CITY OF TROUTDALE

PLANNING COMMISSION STAFF REPORT

**TYPE III FLOOD HAZARD PERMIT with concurrent SITE AND
DESIGN REVIEW and VARIANCES
FILE NO. 13-047 ODOT Multi-Use Trail Extension
under the I-84 Sandy River Bridges**

STAFF REPORT DATE: January 8, 2014

Flood Management Area

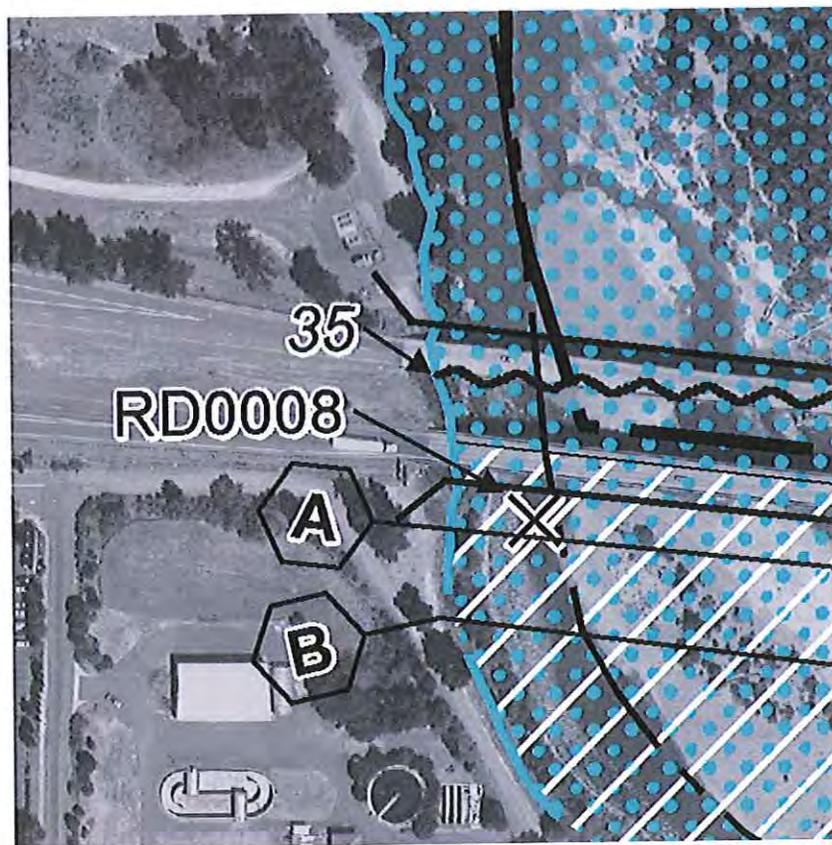
The BFE on the detail for the path under the bridge identifies the "100 yr" elevation at 37.3 feet. However, because the BFE varies along this reach of the river, the detail and plan drawings for the trail must accurately show the elevation of the BFE based upon the flood profile for the Sandy River in the FIS (Attachment 3) (condition number 1).
